# **ATTACHMENT 5**

RE: Preliminary Plan #1-06010  
Rock Creek Woods

We have completed our review of the preliminary plan dated 7/29/05. This plan was reviewed by the Development Review Committee at its meeting on 9/12/05. We recommend approval of the plan subject to the following comments:

## WSSC Comments on Items for September 12, 2005, Development Review Committee Meeting

Pathway  
Alignment

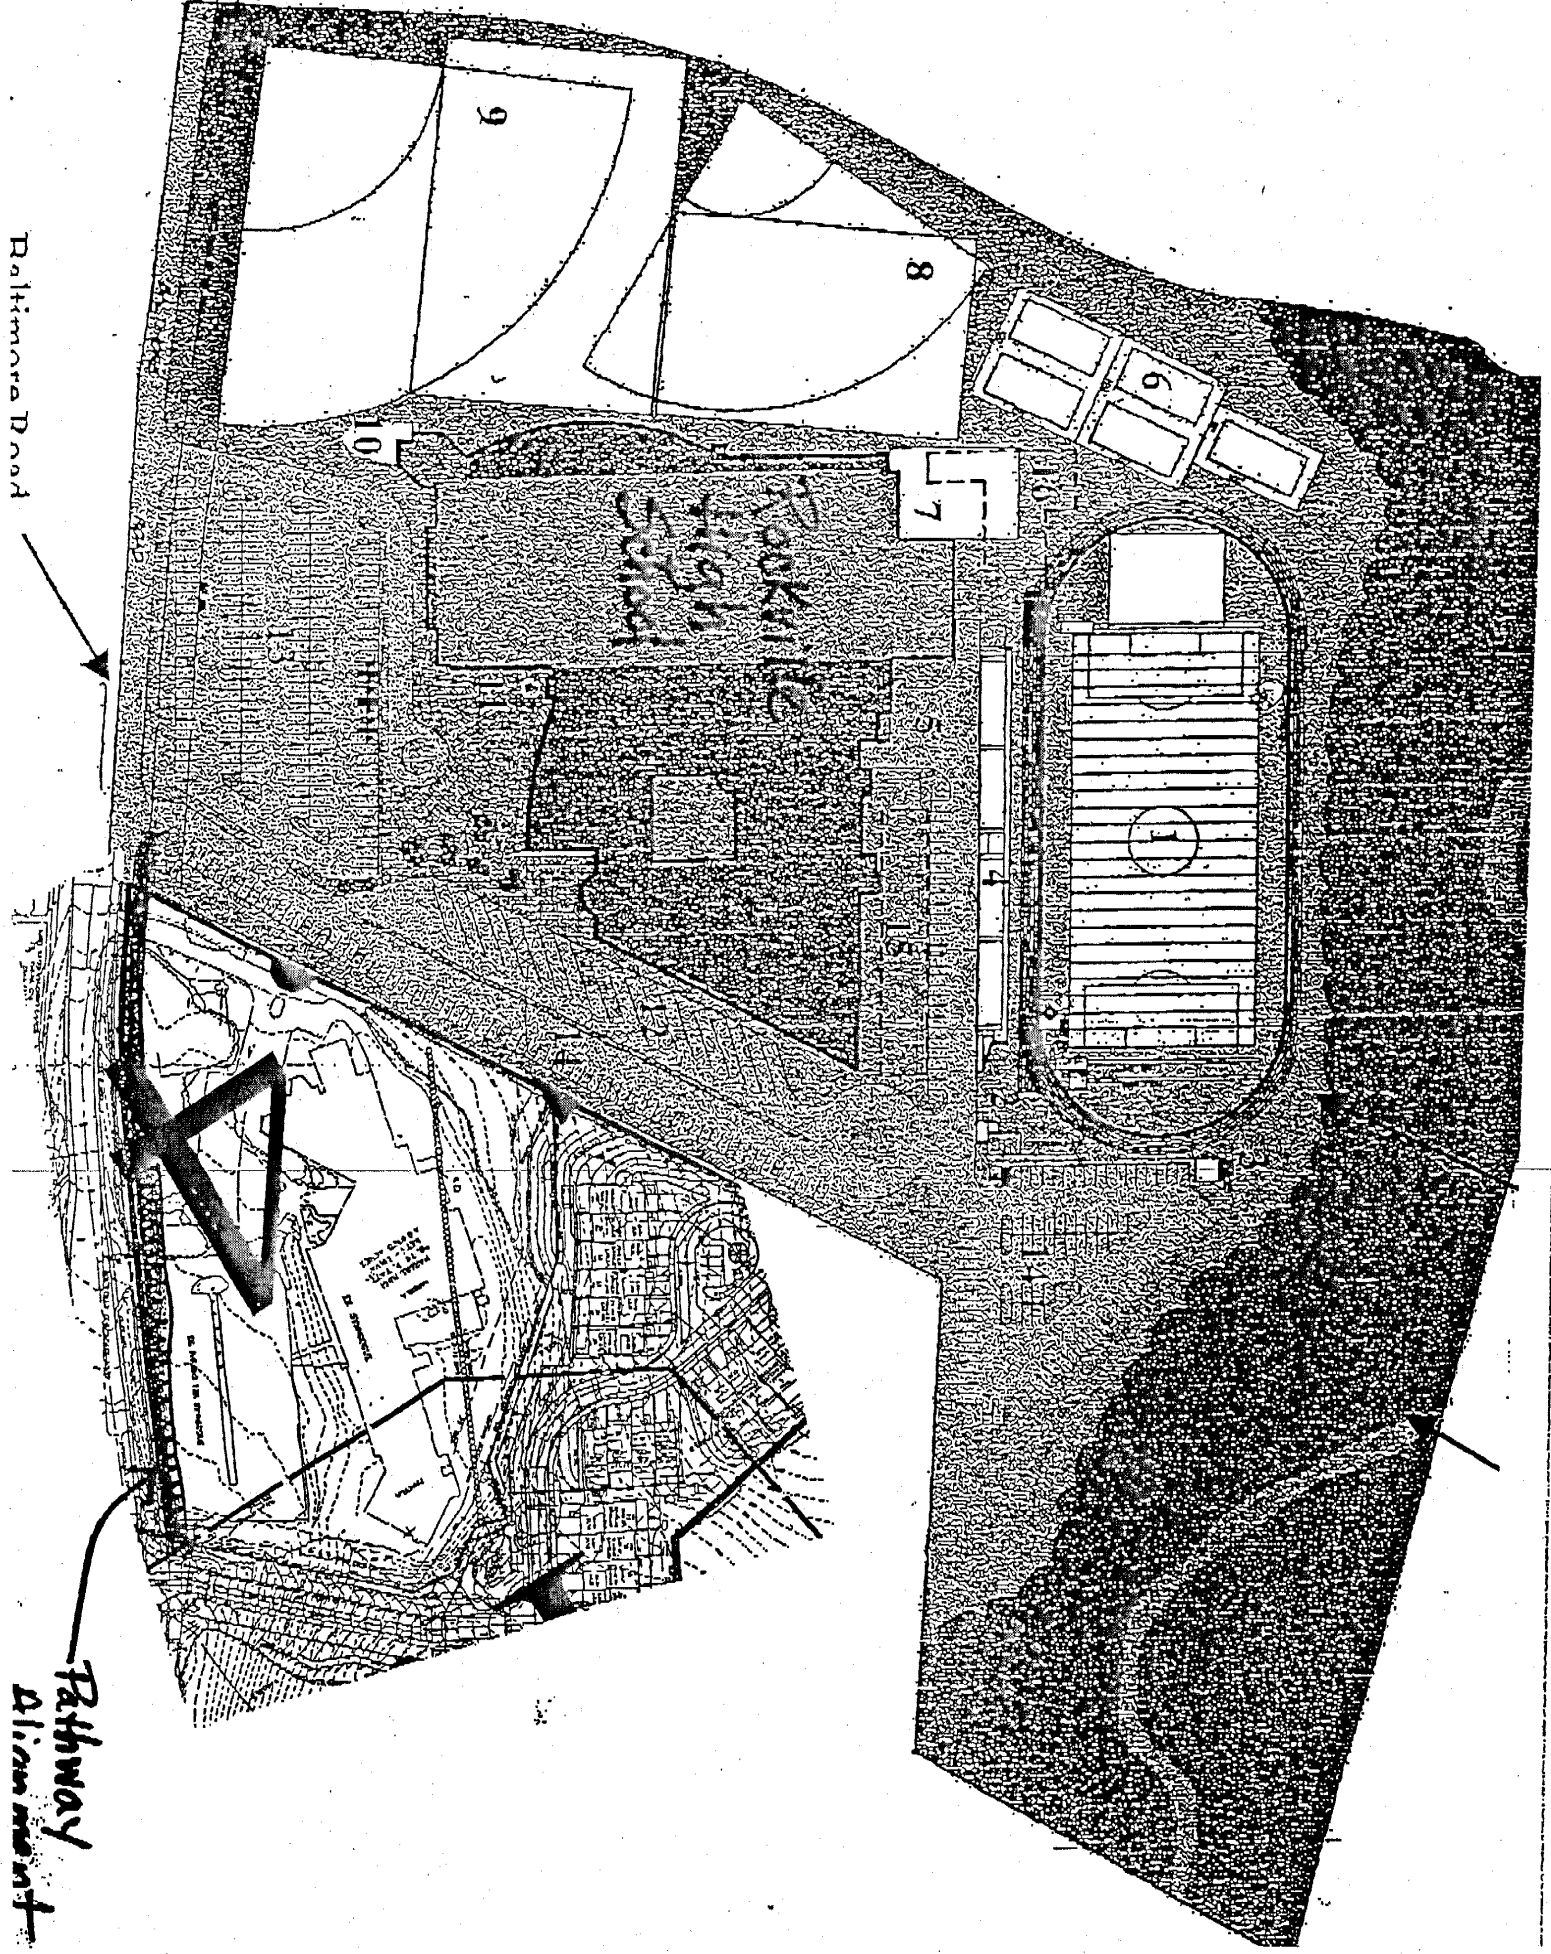
This is to comment on the referenced preliminary and site plans that were presented to the Development Review Committee on September 12, 2005. We request that as a condition of Preliminary and Site Plan approval, the Applicant provide adequate pedestrian connection from the proposed subdivision entrance road to the Rockville High School driveway. Montgomery County Public Schools will grant the necessary right of entry to allow the continuous connection. A drawing is attached that shows the preferred connection highlighted in red.
